Minutes 9 22 2015 meeting

Transport Beam Line

Low Energy RHIC electron *Cooling*

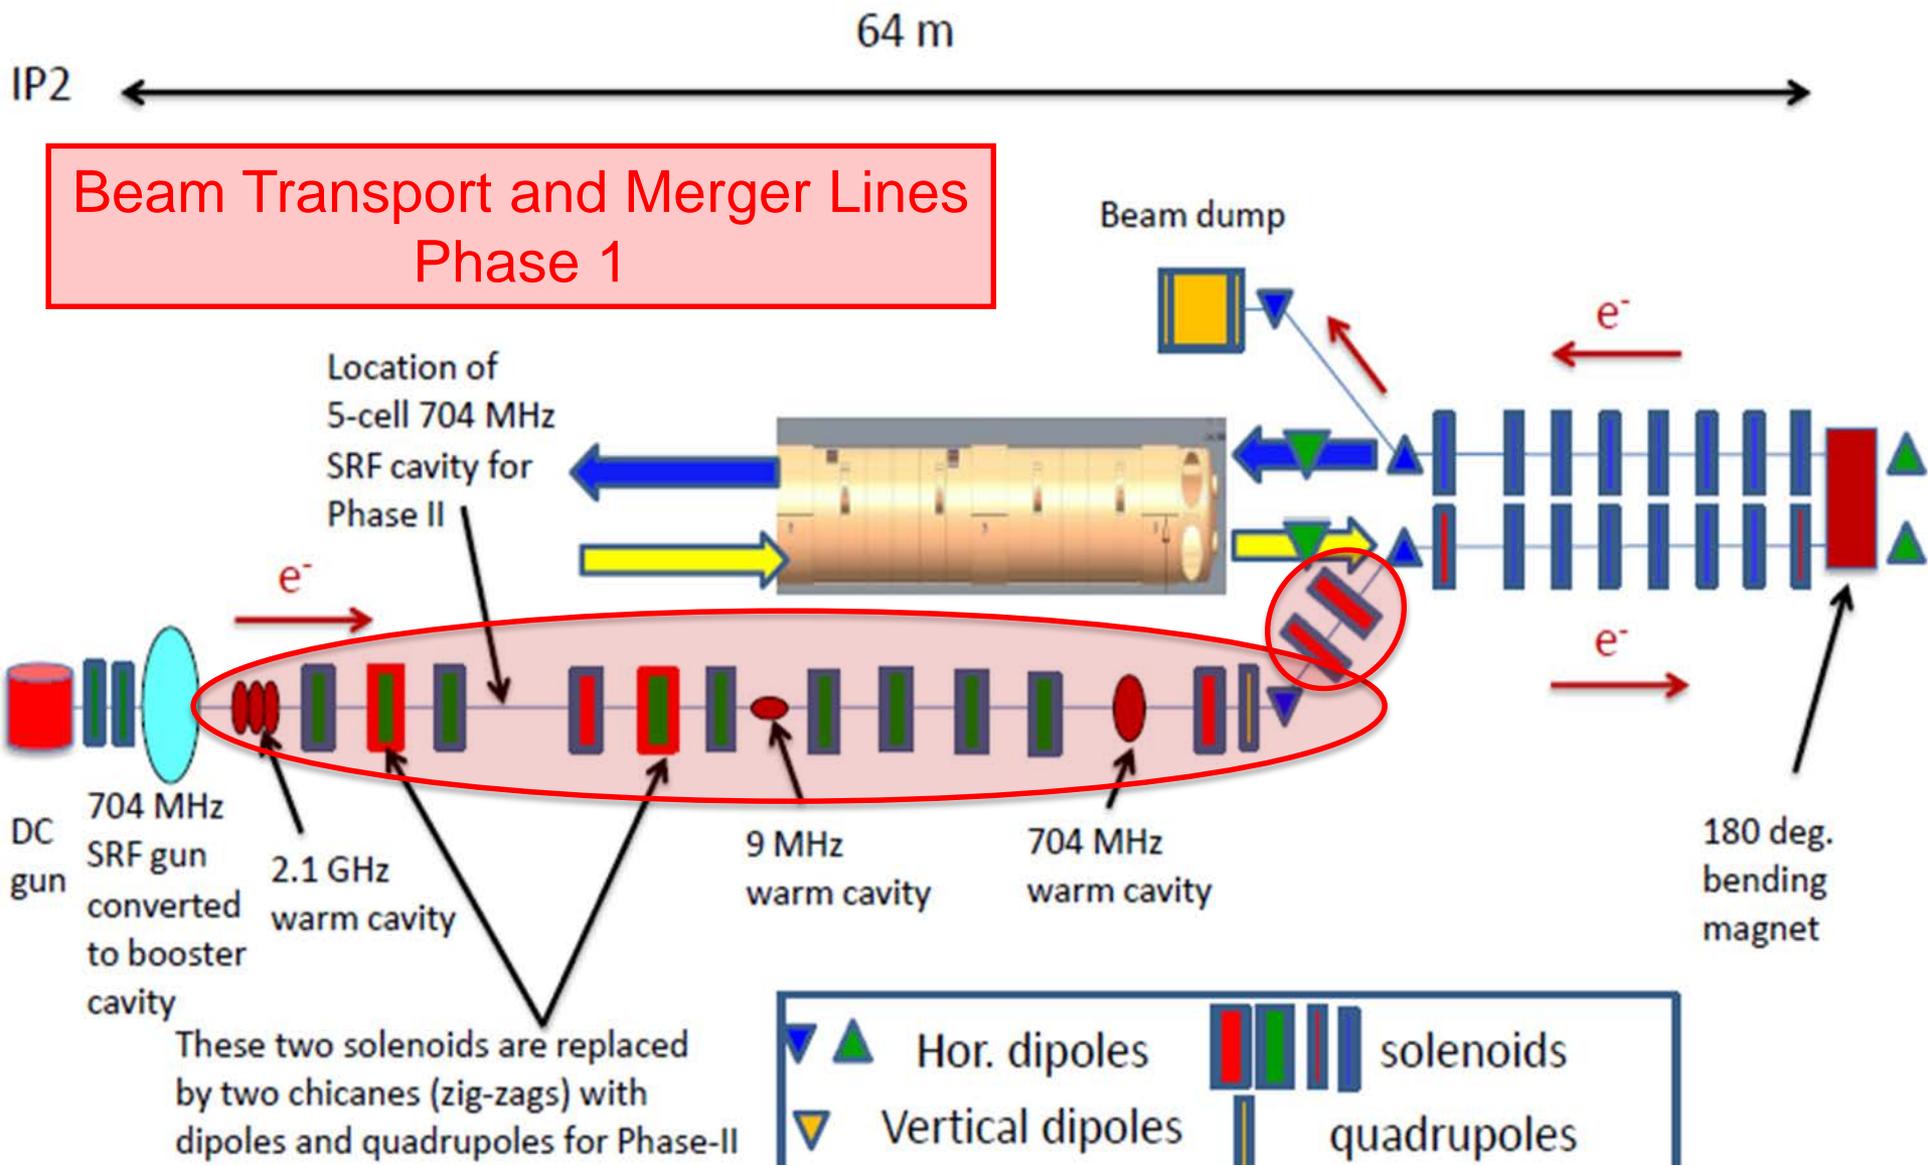
Solenoid magnets: 1000 Gauss Merger solenoids, 535 Gauss Matching solenoids. These solenoids are designed for 2.5” pipe. They have $R_i=5.08\text{cm}$, $R_o=16.84\text{cm}$. The Merger Sol. is 14.8cm long; the Matching Sol. length is incorrectly shown at 14.8 (should be about 11cm).

- Should just the high field solenoid be purchased? Its field requirement is 2x the low field; it may be cost effective to purchase just one magnet type. Same thought for power supply.
- Should the horizontal and vertical corrector be integrated into the solenoid design. Field requirement is 100 g/cm; Wuzheng is analyzing.

- Transport line shows 3 quadrupoles (in Phase II), In Phase II two solenoids are replaced by Zig-Zags (and associated dipoles).
- Correctors at DC eGun: There is a Cornell designed dipole corrector at the Cathode position (air side) and a corrector inside the first solenoid, also designed by Cornell. Maybe this corrector can be integrated into the solenoid design.

Diagnosics - Beam Transport TM

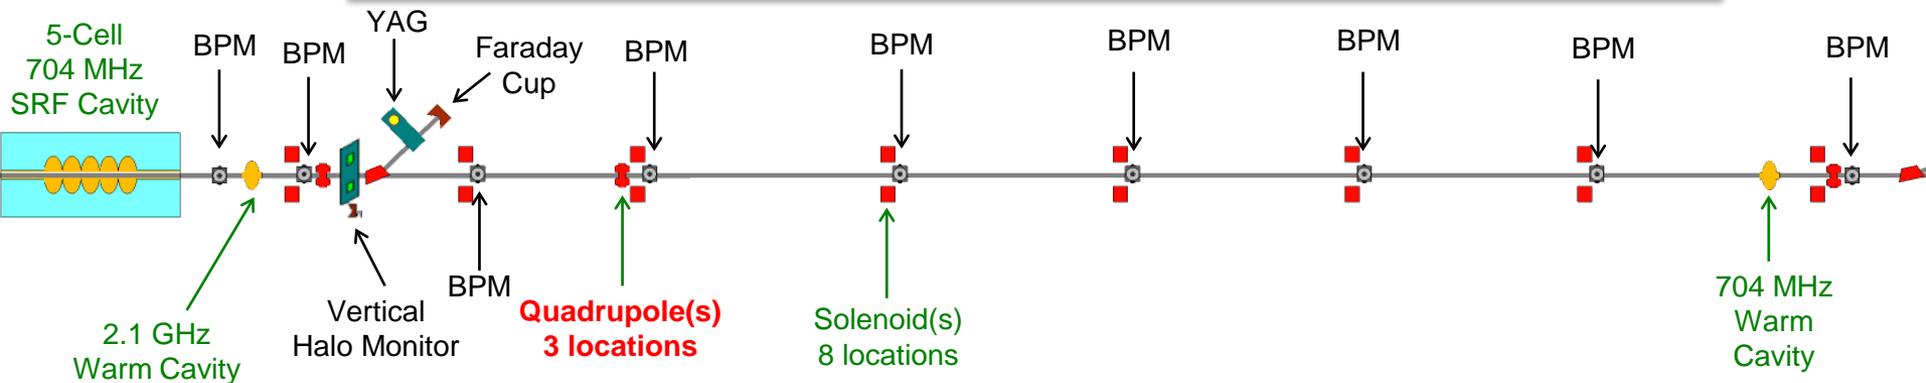
1. 1st Diag. B/L for commissioning
2. Do we need to add YAG in transport?
3. REVISED LAYOUT BELOW – Per Jorg’s model
4. Do we need more emittance measurements in transport? Could add Quad + PM... -> not in baseline and money is too tight

Merger & Diagnostic Beam Lines™

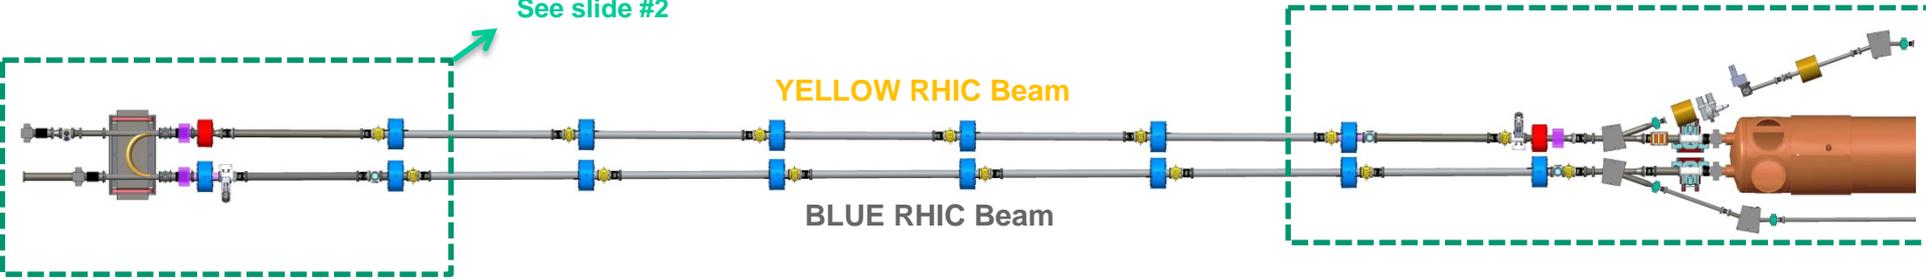
1. Drift length for RF deflecting cavity not know.

2. Need electrostatic kicker and beam dump parameters for diagnostic line.

3. Waiting on information from the Cornell RF deflecting cavity design.
